SUBDIVISION REVIEW SHEET

CASE NO.: C8J-2016-0188.01.1A

SUBDIVISION NAME: Easton Park Section 2C Phase 4 Final Plat

CITY OF AUSTIN – TRAVIS COUNTY – SINGLE SUBDIVISION OFFICE
SUBDIVISION APPLICATION – MASTER COMMENT REPORT

LOCATION MAP
NOT TO SCALE

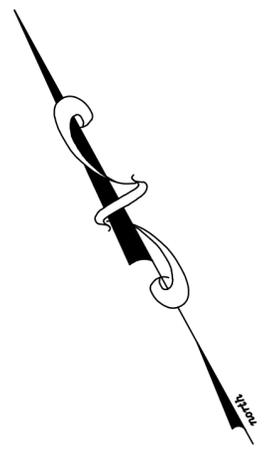
AD2: Please update label for **E WILLIAM CANNON DR** the street type DR must be included in the location map

AD3: Please remove all forms of punctuation after abbreviating street types or directional including streets in the location map and label the streets as seen below:

AD4: Please update label for **THAXTON RD** the street type RD must be included in the location map

AD5: Please update label for **SASSMAN RD** the street type RD must be included in the location map

- 1. E WILLIAM CANNON DR**
- 2. COLTON BLUFF SPRINGS RD**

SHEET NO. 2 OF 3

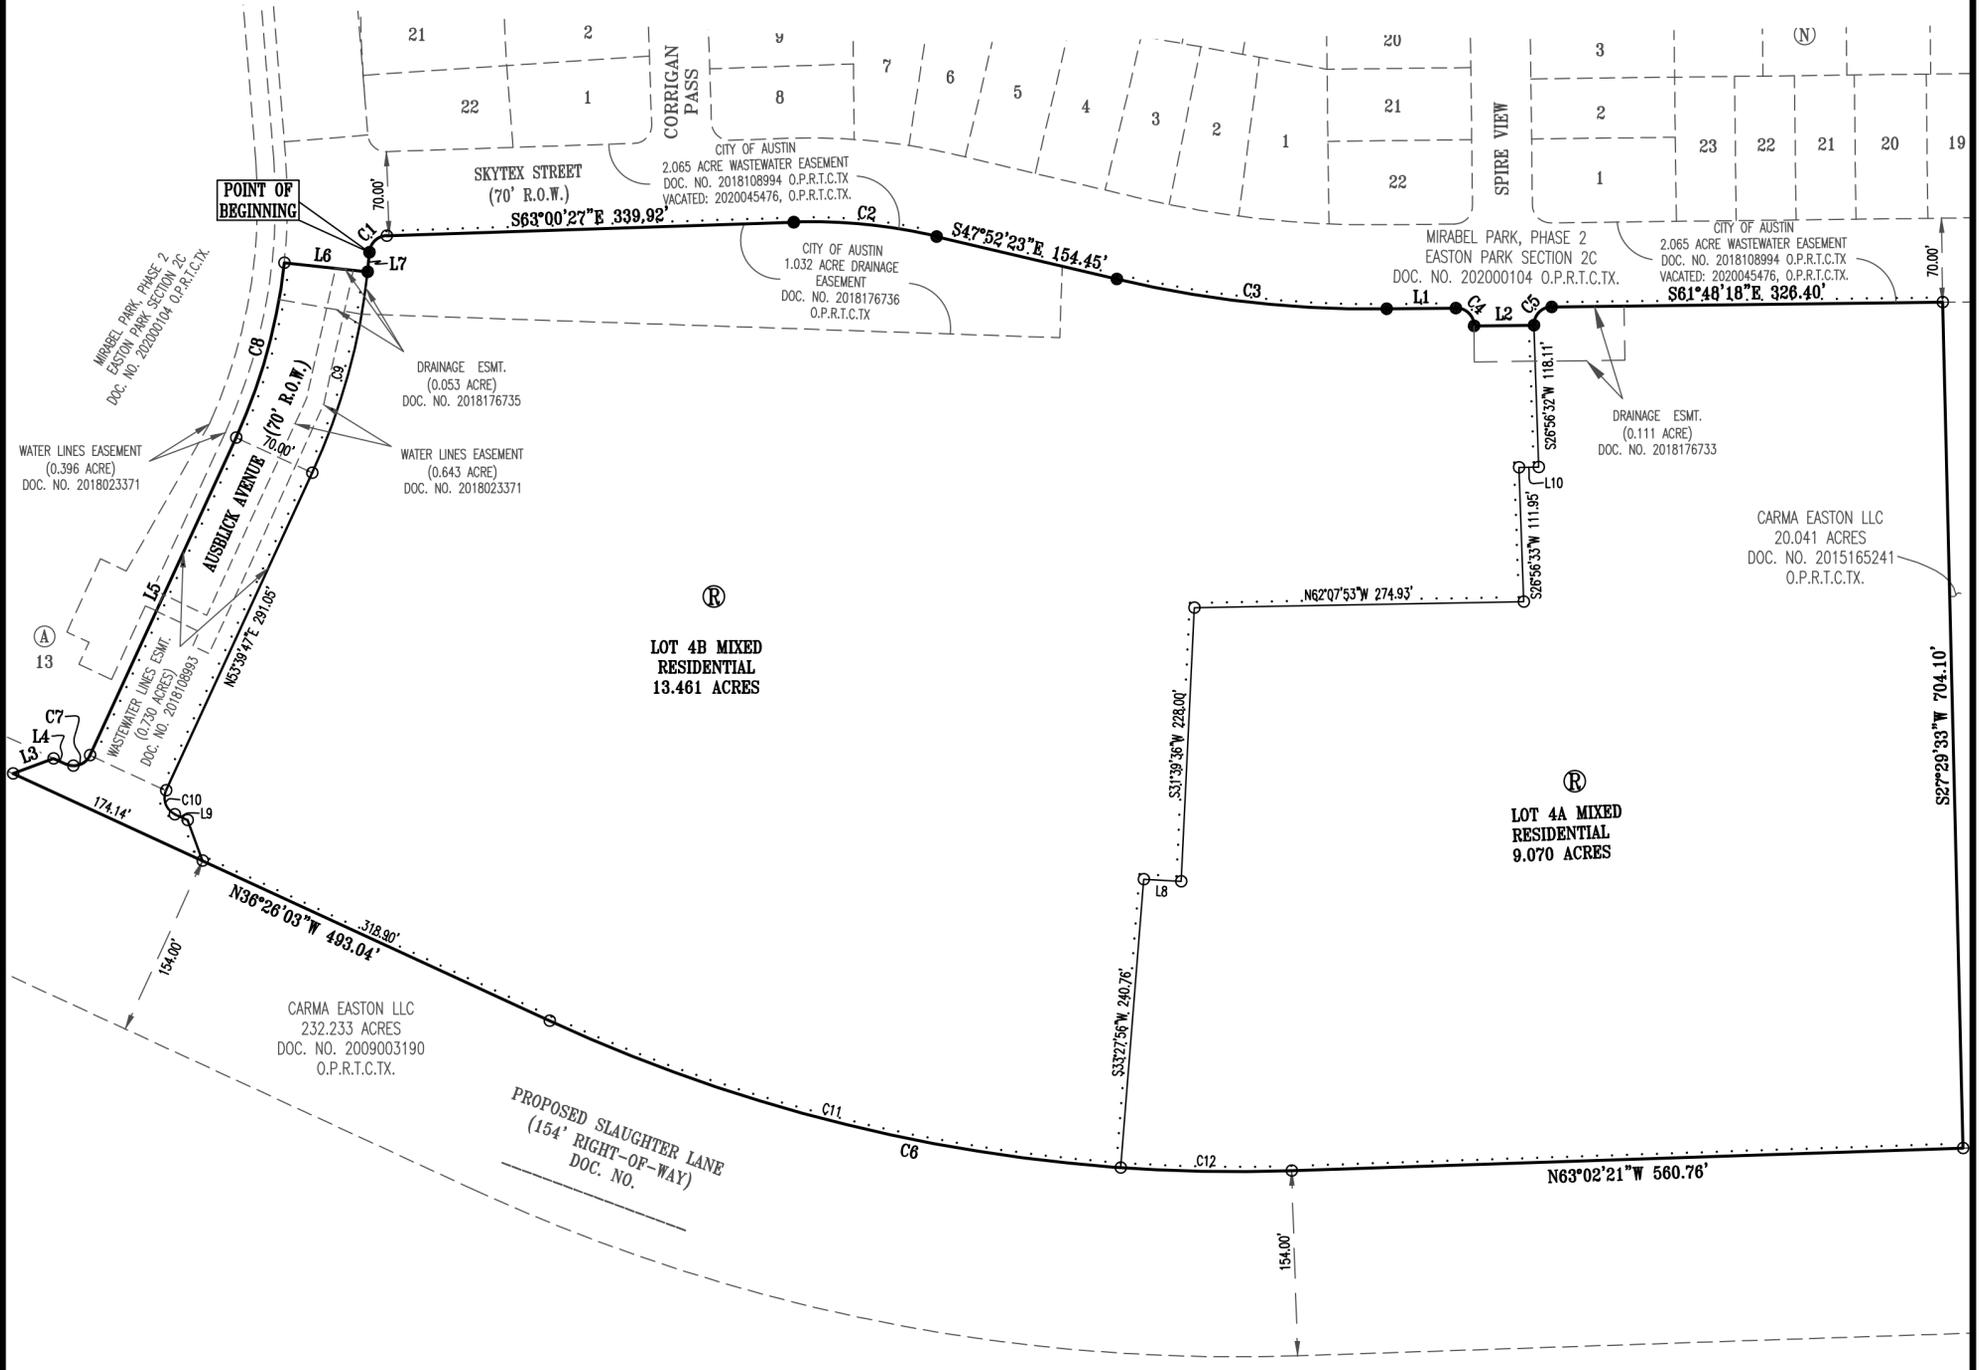
AW2. Per Utility Criteria Manual Section 2, §25-4:
Wastewater easement in Skytex St does not appear to match our records. Correct or provide documentation.

- 1) Proposed Ausblick conflicts with easements 2018108993, 2018176735 and 2018023371. These need to be vacated. 30-1-113
- 2) Add the following plat note: Within a sight line easement, any obstruction of sight line by vegetation, fencing, earthwork, buildings, signs or any other object which is determined to cause a traffic hazard is prohibited and may be removed by order of the Travis County Commissioners Court at the owner's expense. The property owner is to maintain an unobstructed view corridor within the bounds of such easement at all times. 30-1-113
- 3) If Slaughter is not constructed prior to the extension of Ausblick, a turnaround will be required (per Phasing Agreement).

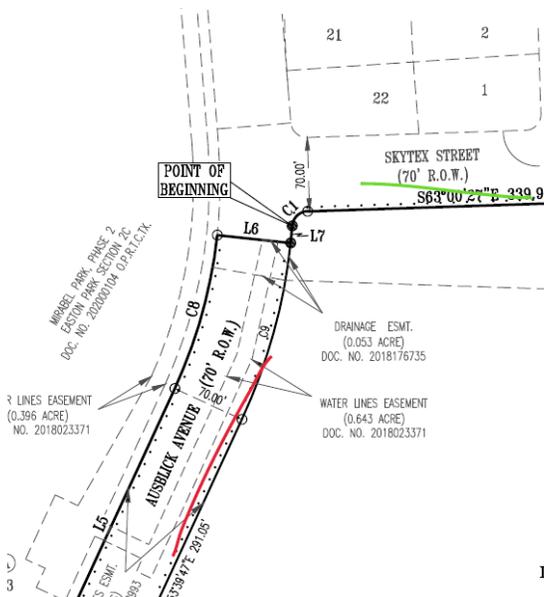
AD6: Where AUSBLICK AVE is labeled, the labels should be as follows: **AUSBLICK AVE (Proposed)**. Optionally, the word PROPOSED enclosed within parenthesis, may be placed below the street name label. Please update AUSBLICK AVE (Existing) for the built section north of the existing label.

No punctuation should appear in the street name label. Example:

**AUSBLICK AVE
(Proposed)**
